IFB 19-20-066
"Airport Drive: Northside Multi-Use Trail"

Addendum No. 2

**AIRPORT DRIVE: NORTHSIDE MULTI-USE TRAIL
FROM: AIRPORT RD TO: 0.237 MI. NORTH OF AIRPORT RD**

ADDENDUM 2

TYPICAL HYDRANT ASSEMBLY INSTALLATION

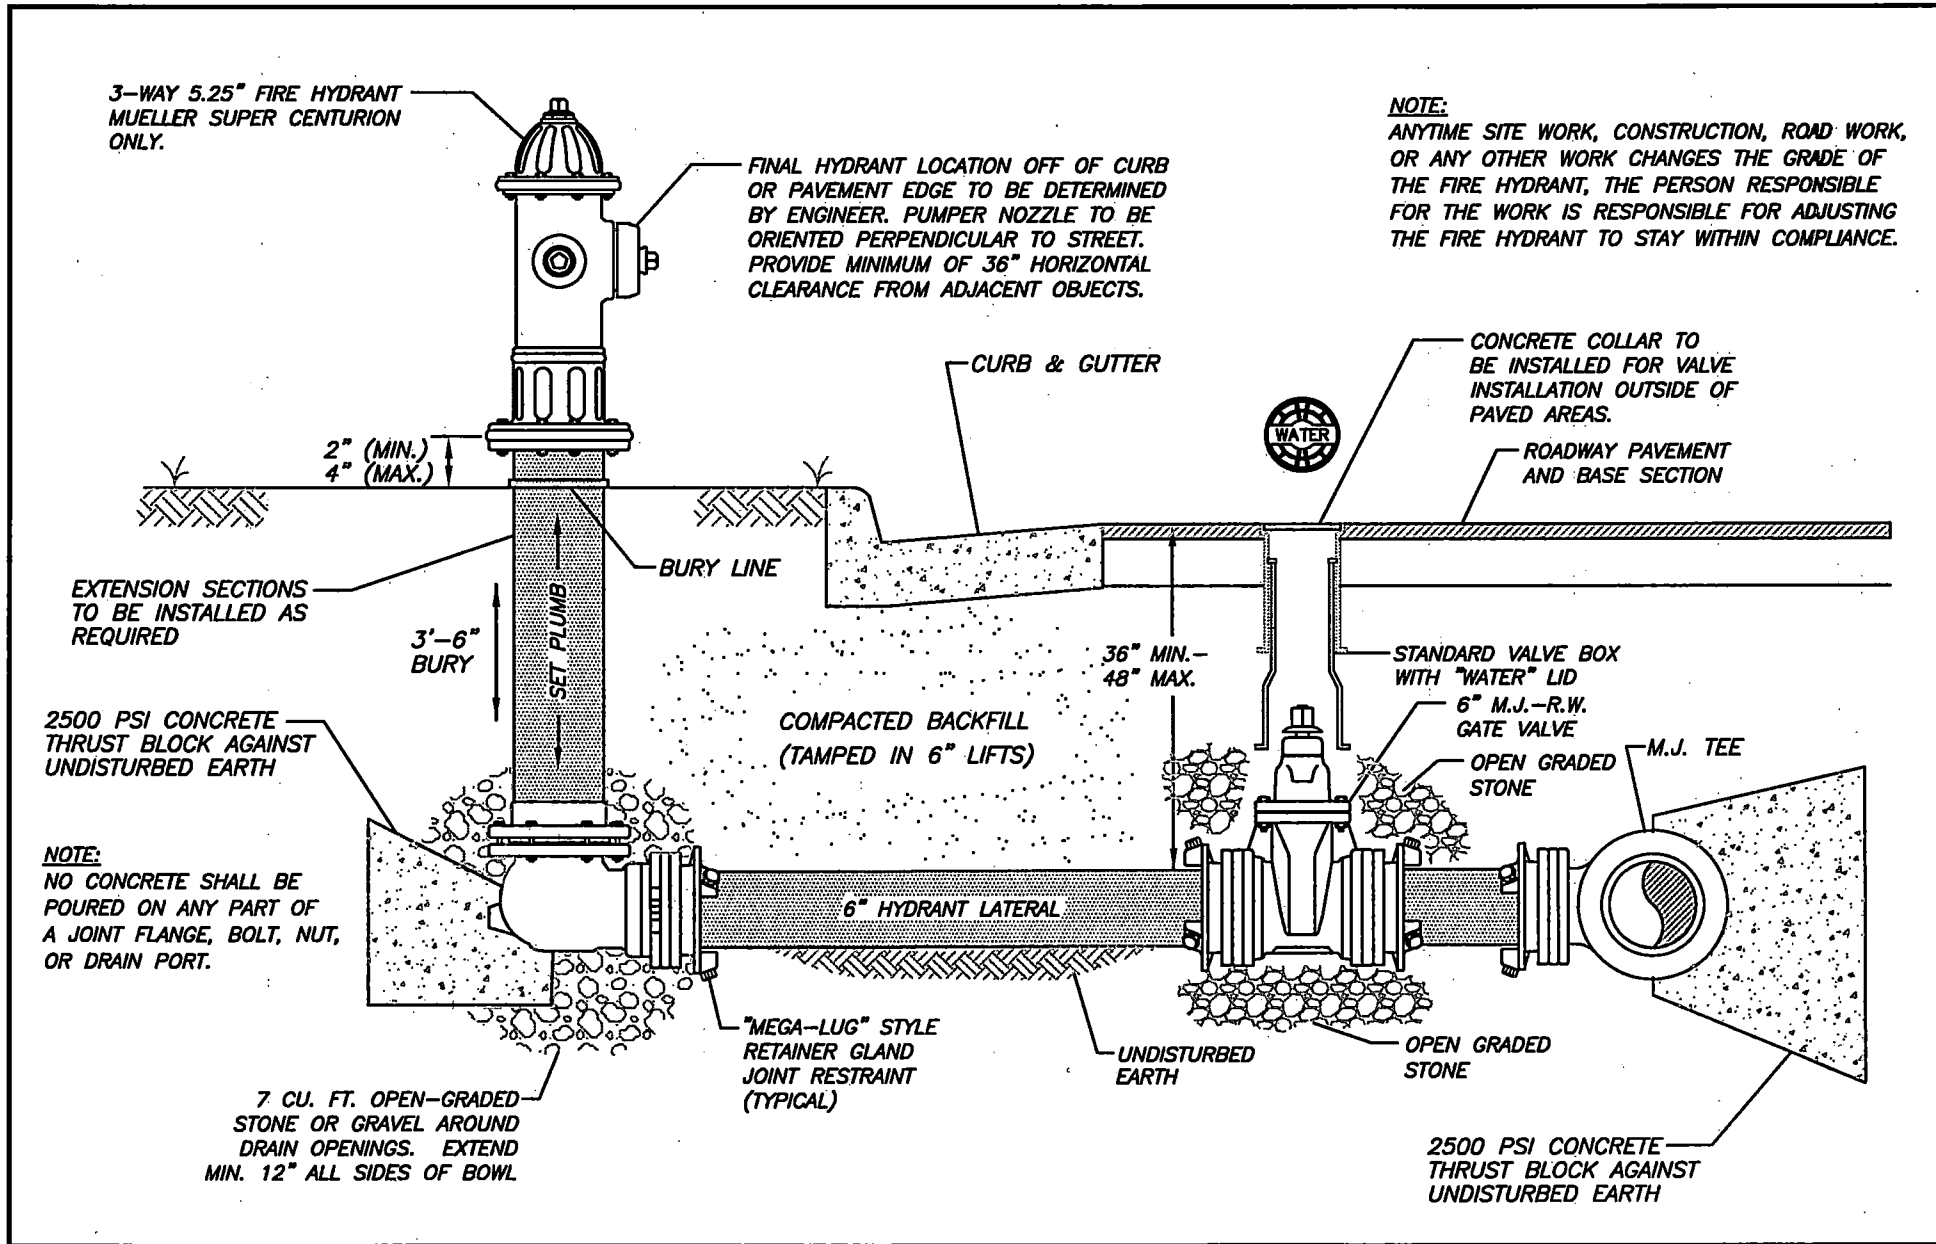
5. Five (5) water/gas valves will need to be adjusted. See revised bid form, line number 7.
6. Fire Hydrant relocation. See attached "Typical Hydrant Assembly Installation" detail. Note: the fire hydrant valve will not be relocated, but will need to be adjusted to trail grade.
